# Access Compliance Report

## Public Rights-of-Way

| Intersection ID: 50707                  | Main Street: CONGREGATION_DR | Cross Street: BROTHERLY_LN              | Location: S            |
| ADA ID: 5D3389115E55                    | Ramp Type: Perp              | Initial Pass/Fail: Fail                 | Overall Compliance: No |

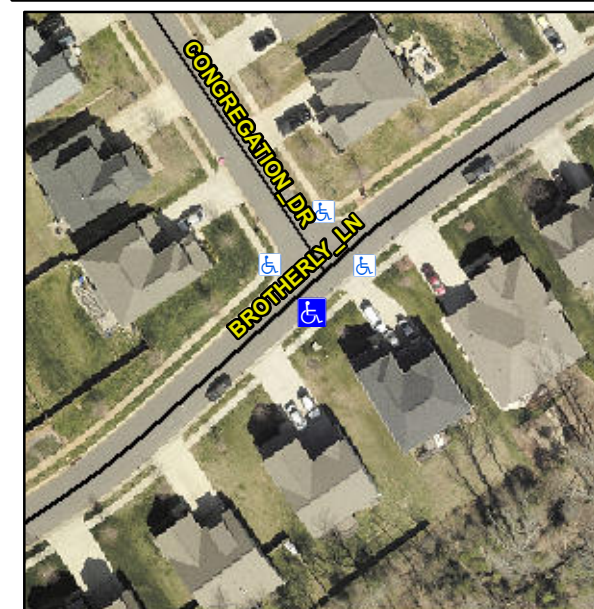
**Not Found, R304.5.1, R304.2.2**

| Compliance | Description           | Data  | Compliance | Description                 | Data |
|------------|-----------------------|-------|------------|-----------------------------|------|
| N/A        | Ramp Length (in)      | 48.0  | No         | Ramp Slope (%)              | 9.0  |
| No         | Ramp Width (in)       | 47.0  | Yes        | Ramp XSlope (%)             | 0.3  |

**Remove & Replace Entire Ramp.**
